Change Order Request

Project: 1923025-02
La Crosse Center Expansion & Renovation
400 La Crosse Street
La Crosse, WI 54601

COR # 79.00

PCO # 130 - RFI 163 Restroom Powered Devices

1 ARENA LEVEL SANITARY PLAN - AREA A
1/8" = 1'-0"

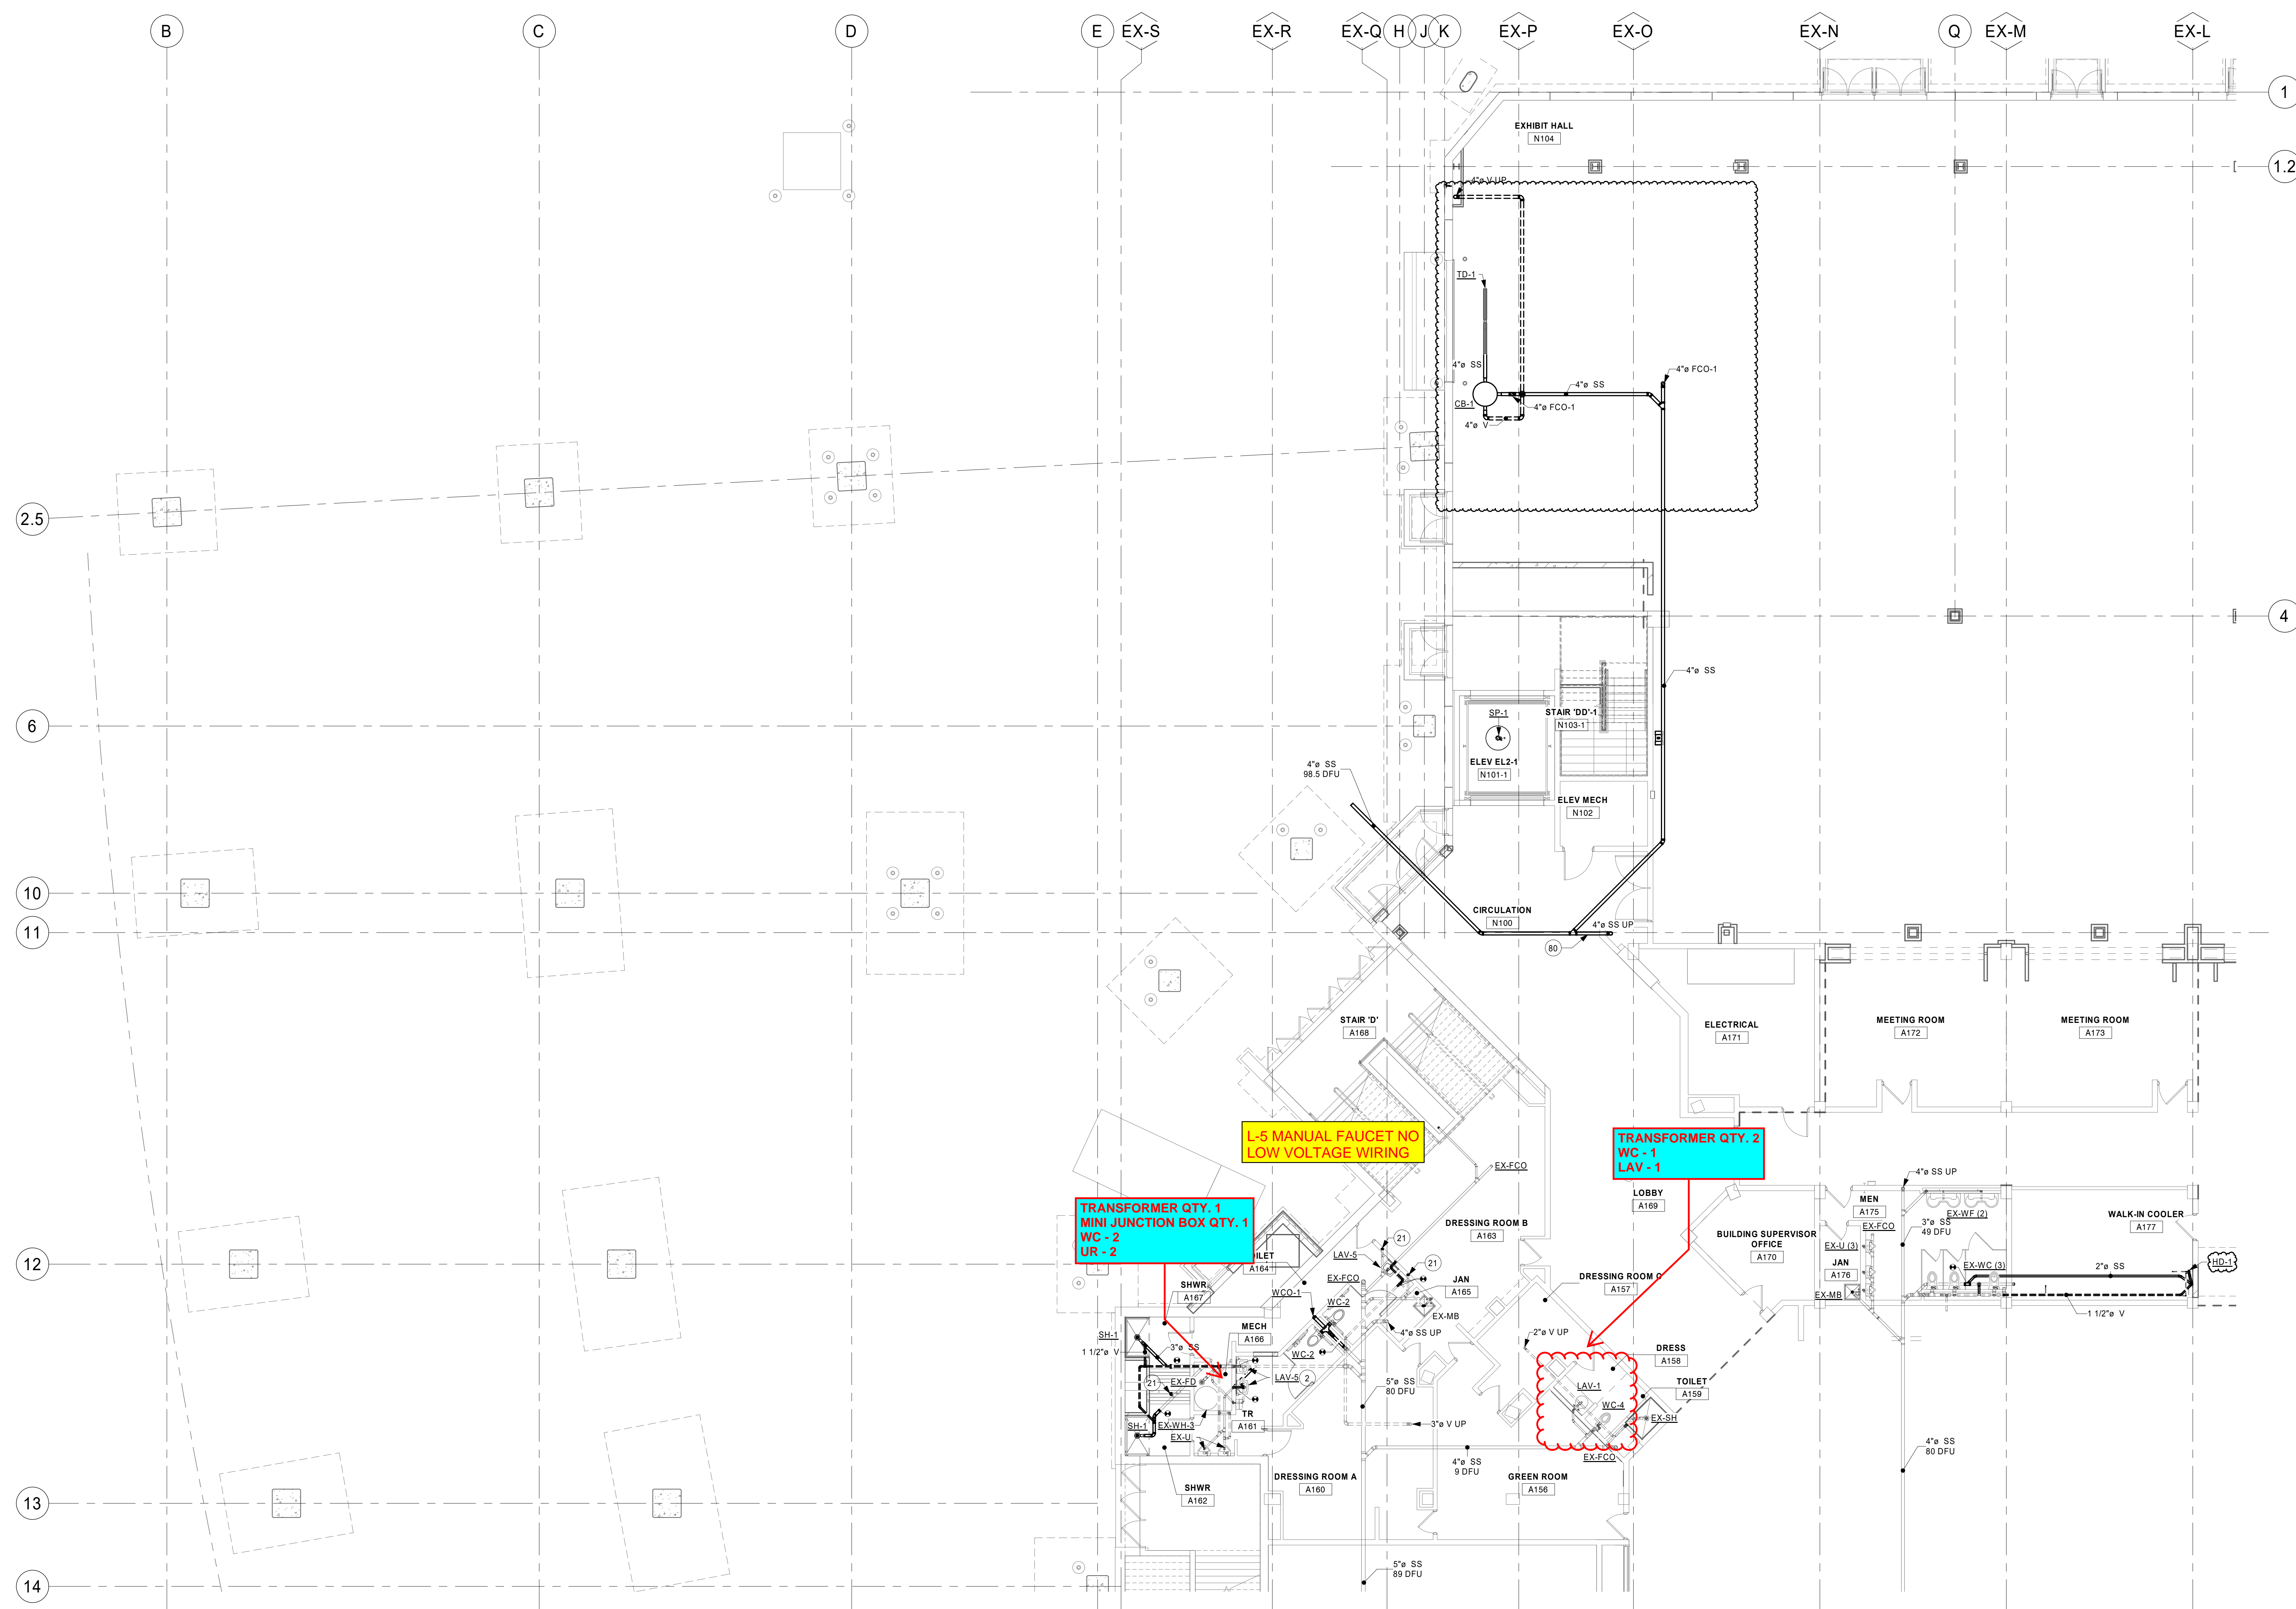
Zimmerman shows restrooms A144, A139, A149, A161, A164, A157 and A158 as having powered toilets, urinals and select faucets - from what we can see our plans do not show this. Please see attached and advise.

Rooms A139, A144, A149, A158, A161, A164 have auto flush valve toilets. We would need to add power these locations from the nearest available 120volt circuit.
